Date 13 May 2025
Our ref APL/00459/JOS
Your ref 2025/1348/P

Objection to Planning Application at 26 Rosslyn Hill London NW3 1PD

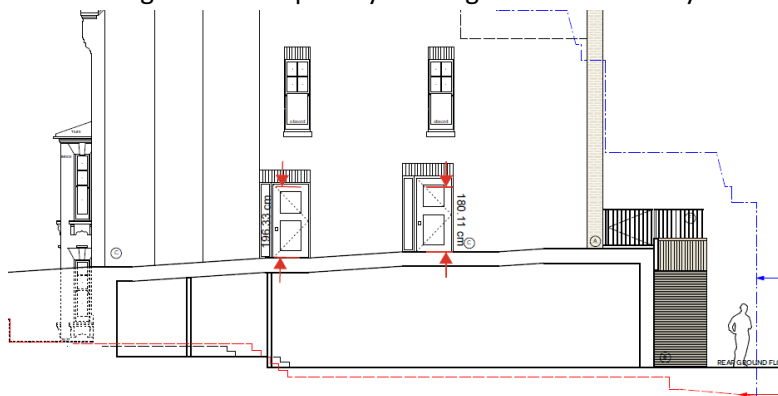
1. Drawing 2408_L_041 RevA indicates that there is a change in levels proposed as part of the development between the existing car park (77.63mAOD) and the new rear garden (79.27mAOD), an increase of 1.64m. However, there appear to be inconsistencies between different drawings – the elevational drawings would suggest that the increase is 1.2m (see extract on the following page). In order to properly understand the impact on the adjoining property, accurate plans are needed. We trust that you will require the applicant’s team to provide these and re-consult? Please confirm.

2. The extract above also shows that the upper ground floor level is only 0.85m below the height of the boundary wall with Mr and Mrs Joseph's property, consequently, there is significant potential for overlooking. There appears to be some form of privacy screen shown on the elevation (1.8m high), however, this is then not shown on the southern elevation (drawing 2408_L_054 RevA), therefore it is considered that further detail should be given to address concerns with regard to overlooking and loss of privacy.

Drawing 2408_L_054 RevA

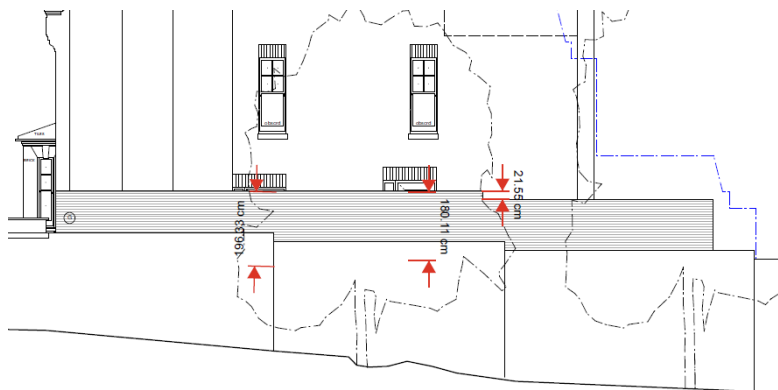
3. Drawing 2408_L_054 RevA (southern elevation) is hard to reconcile with drawing 2408_L_062 RevA (southern boundary treatment). The southern elevation shows that the land will be significantly raised to provide access via the side of the building to the ground floor flat and the upper duplex apartment adjacent to the boundary with 24 Rosslyn Hill. The boundary treatment shows that the timber fence drops by 20cm after the duplex apartment door, meaning that it is only 1.5m high adjacent to the terrace to the upper ground floor flat. Overlooking and loss of privacy to the garden of 24 Rosslyn Hill will arise.

4. The elevations on the preceding page also show windows at first floor level, yet on the proposed first floor plan (drawing 2408_L_043 RevA) these are not detailed. The elevations show them as being obscured, and given that they appear to be to a bathroom and hallway it is considered that a condition should be imposed to ensure that they are obscured and non-opening below 1.7m above finished floor level.

5. In terms of the various elevations provided, they should not be cut off part way along (as is the case, for instance, with drawings 2408_L_054 RevA above), but rather should extend the full length of the site, so that the relationship with the adjacent property can be fully understood. Drawing 2408_L_053 RevA showing the northern elevation, should also detail such features as the boundary wall with 24 Rosslyn Hill and the fencing proposed for the boundary, so that it can be understood how much opportunity there is for overlooking.
